PLAN 3

PLANNING APPLICATION PLN-19-0049

3 TABERNACLE PLACE, PERTH

2 Lot Subdivision and Multiple Dwelling Development

DRAINAGE PLAN
SCALE 1:200

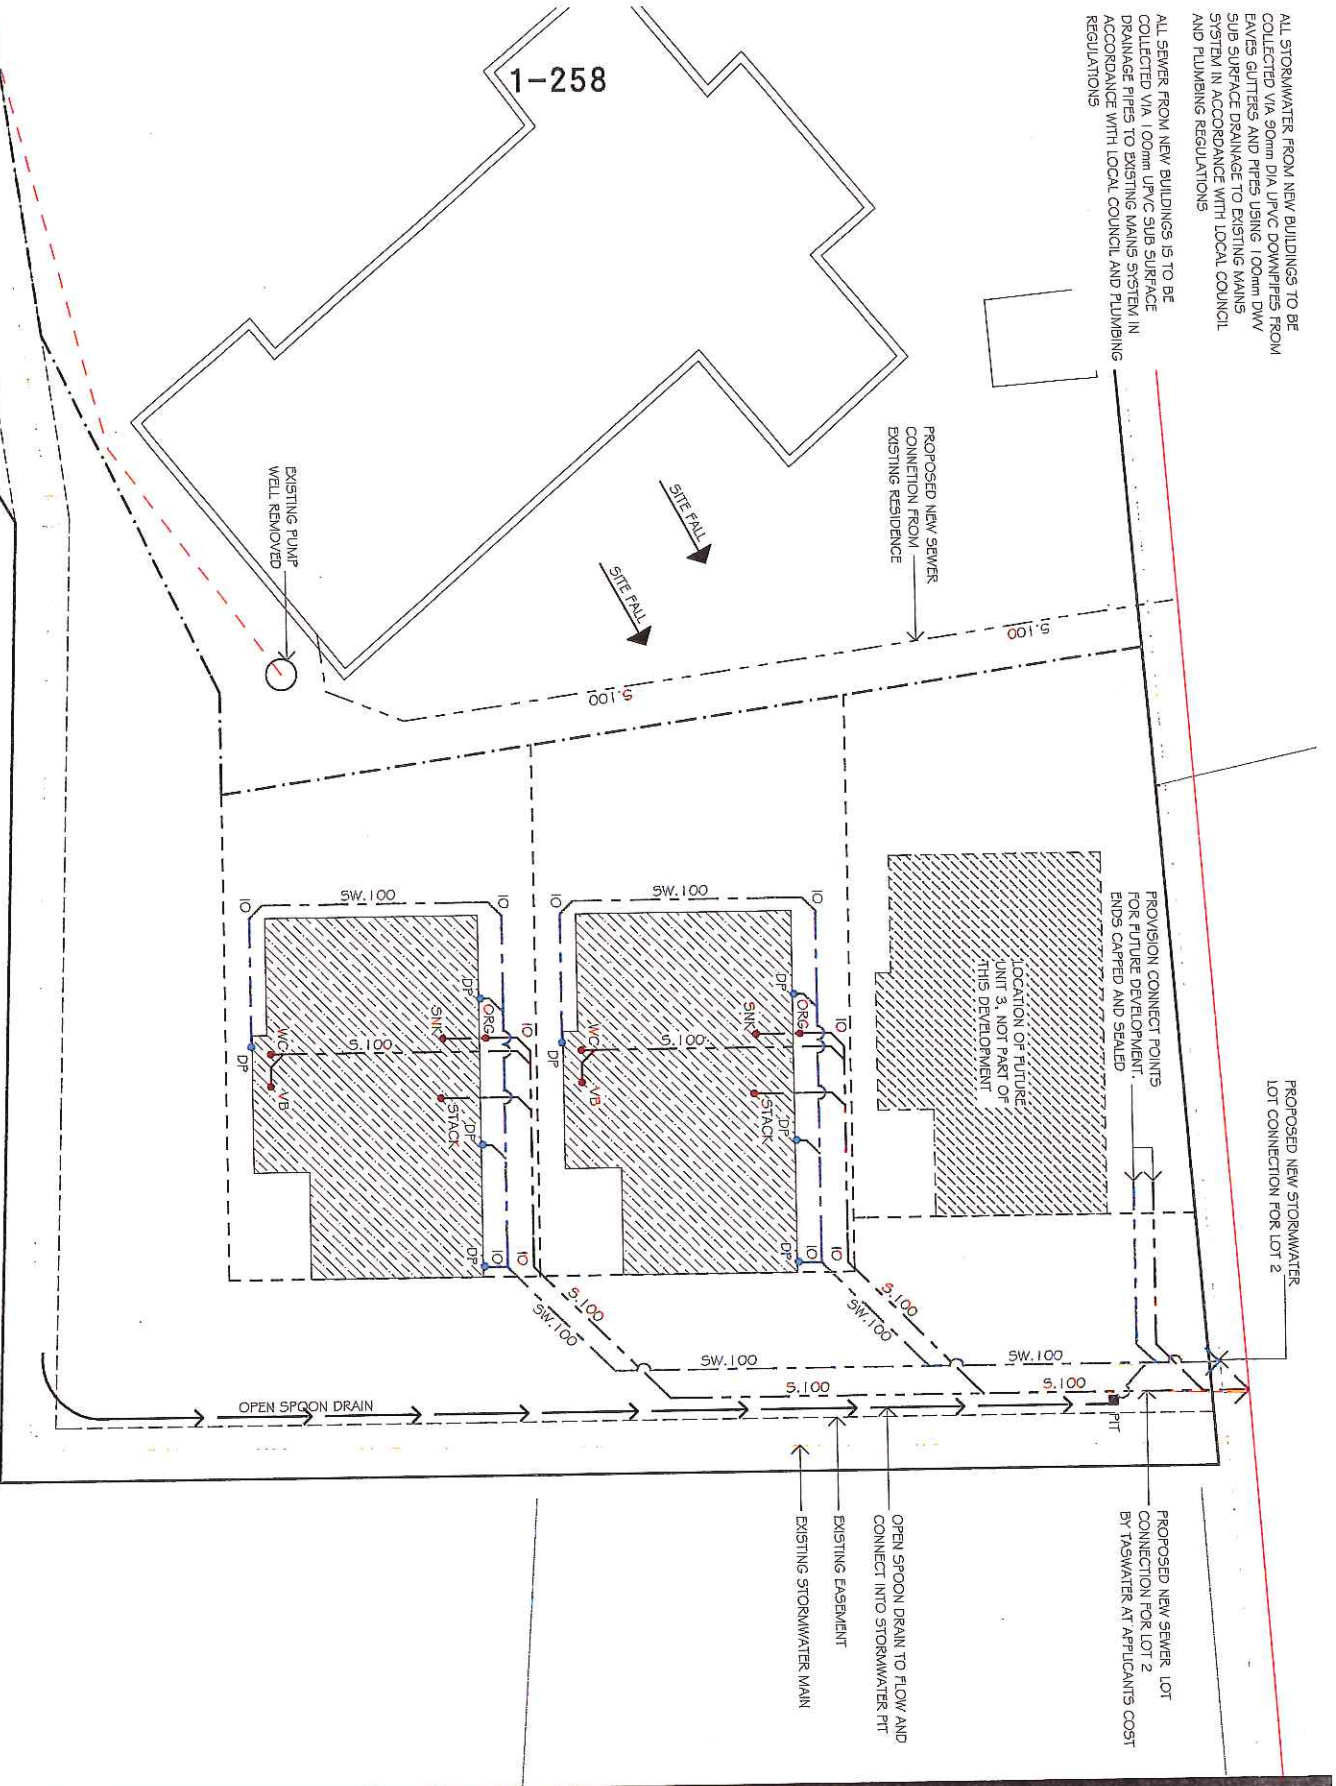
The plan indicates that the sewerage line will need to be redirected into the existing sewerage line at the back of my property 11 Talisker Street.

9am SHADOW PLAN

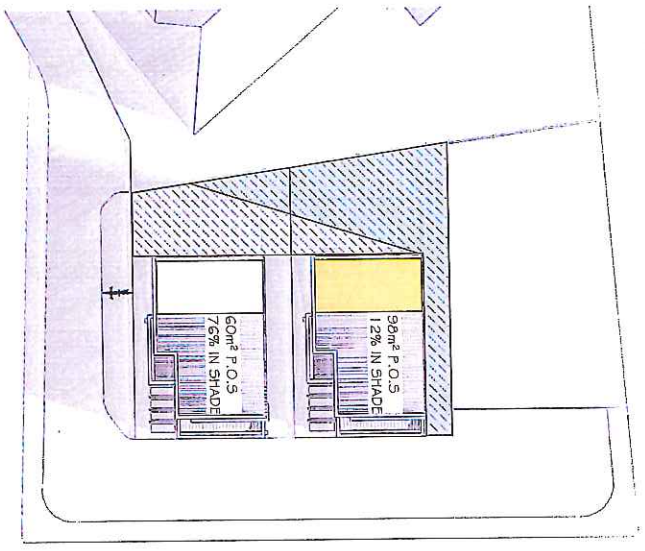
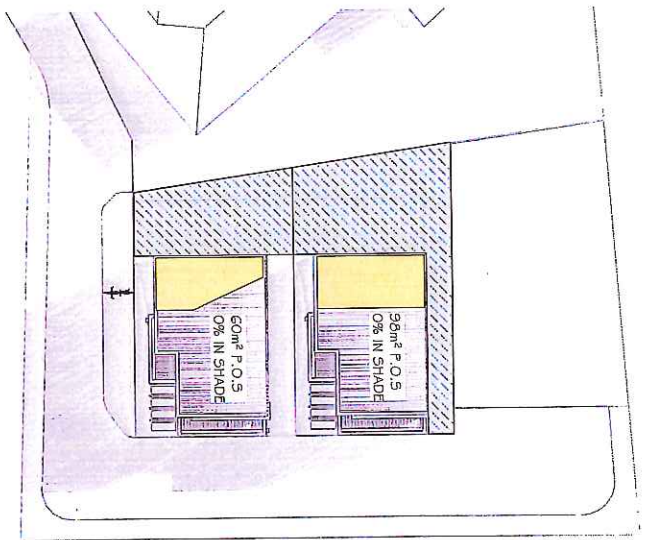
The density, of the proposal is not in keeping with the surrounding areas and the shadow plan supplied does not show the "shadowing: on the to the adjacent properties it just stops at the boundary fence and as we have always enjoyed beautiful late afternoon sun, evening
